ATTACHMENT 1

LOT 54 ON SP292874 BONNIE DOON ROAD, KILLALOE RESPONSE TO REQUEST FOR INFORMATION

Figure 2 - Existing Drainage Paths

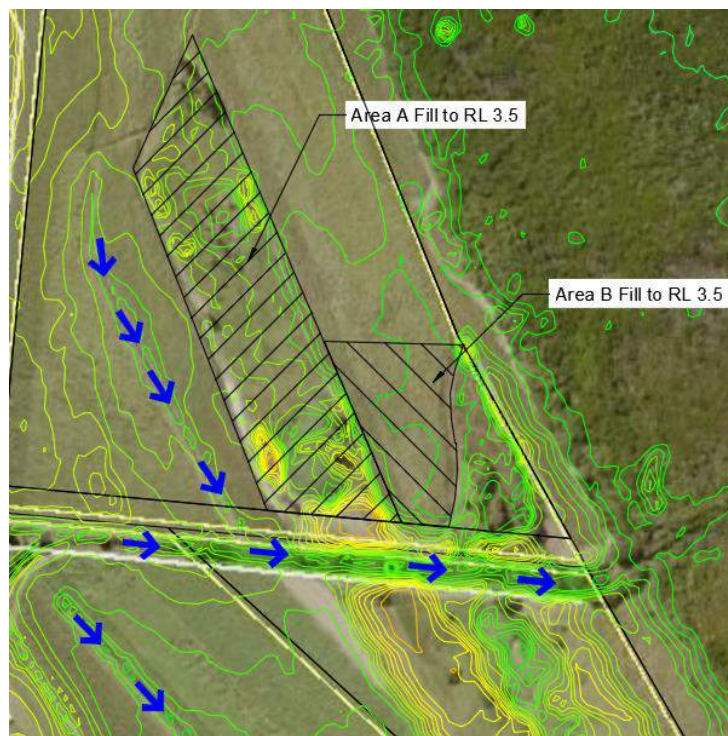
6. Provide sufficient evidence and investigations that the proposed filling works will not adversely impact on the surrounding properties not only from a drainage perspective but also having regard to the salt content of the fill material to be used

Defined drainage corridors exist both to the north and south of the site. These corridors convey upstream flows from the western side of Bonnie Doon Road. The proposed fill area is outside of these corridors and will not impede upstream flows.

From existing contour information, the low point on Bonnie Doon Road is immediately south of the site. Major storm event flows are anticipated to cross here and traverse south through the neighbouring allotment.

The area proposed for fill already has levels in the order of 3.5m and therefore it can be demonstrated that the area proposed for filling is not used for stormwater conveyance.

An existing farm drain is present just west of the filling area, which intercepts runoff between Bonnie Doon Road and the fill area. It is intended that this corridor not be disturbed or impeded.

Figure 1: Nominated Haul Route

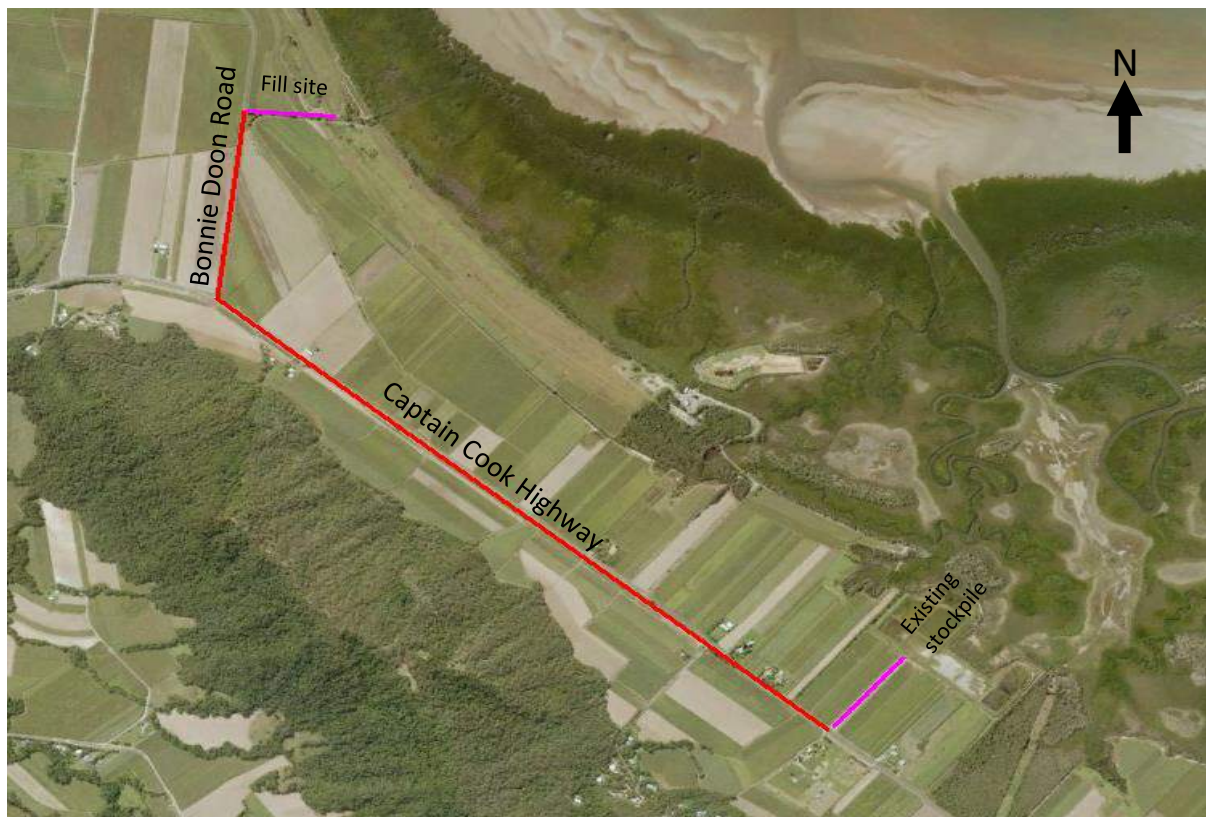
5. Nominate the haul route and undertake a condition assessment of the public road to be used to ensure that at the completion of the work, any damage to Council controlled roads as a consequence of transporting the material can be determined.

The nominated haul route can be seen in *Figure 1*.

The haul route begins at the entrance to lot 3 of SP183025 along the Captain Cook Highway approximately 1300m north of the Coolalinga Drive intersection. The route continues north bound along the Captain Cook Highway until the Bonnie Doon Road intersection. The haul route follows
